January 16, 2018

RE: Grant Subdivision Drainage Letter

MS 17-005

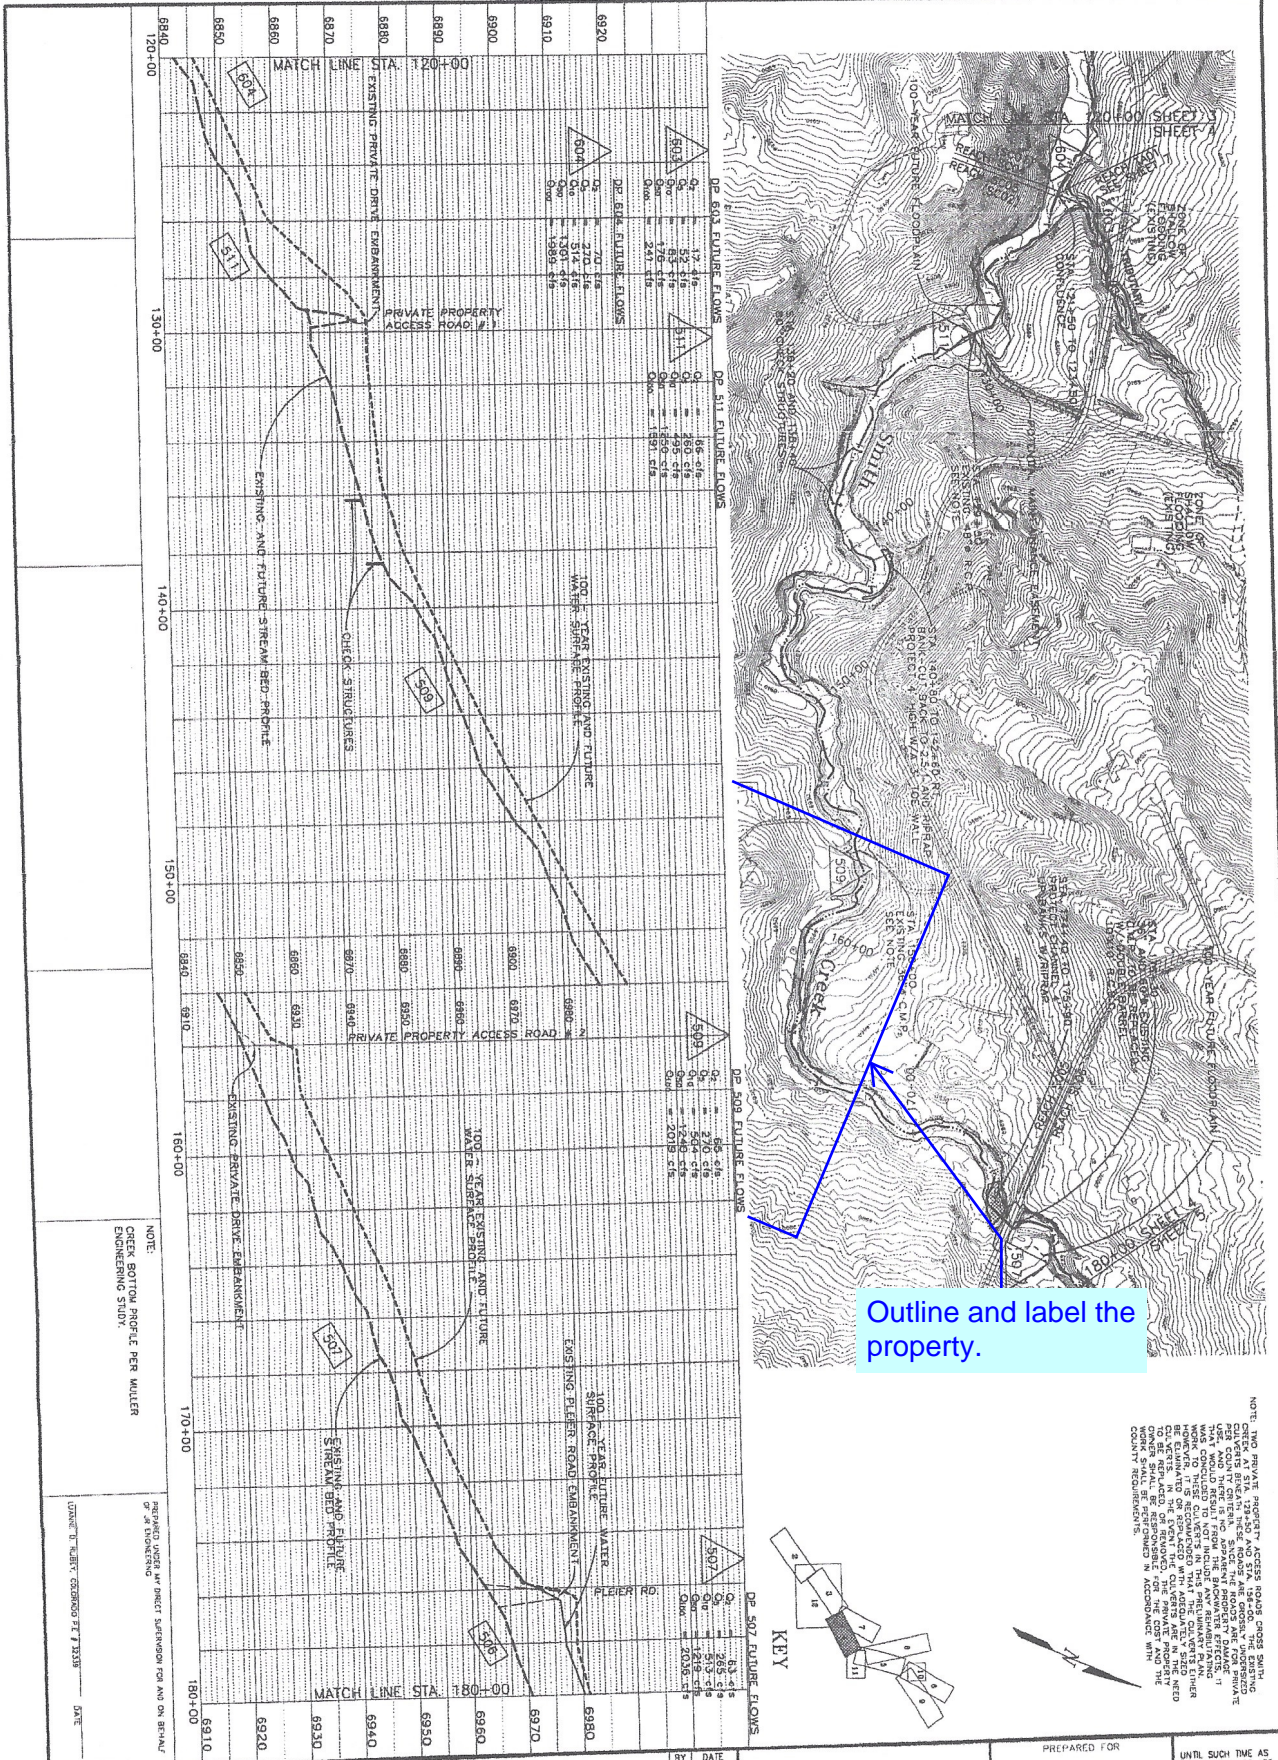
Outline and label the property.
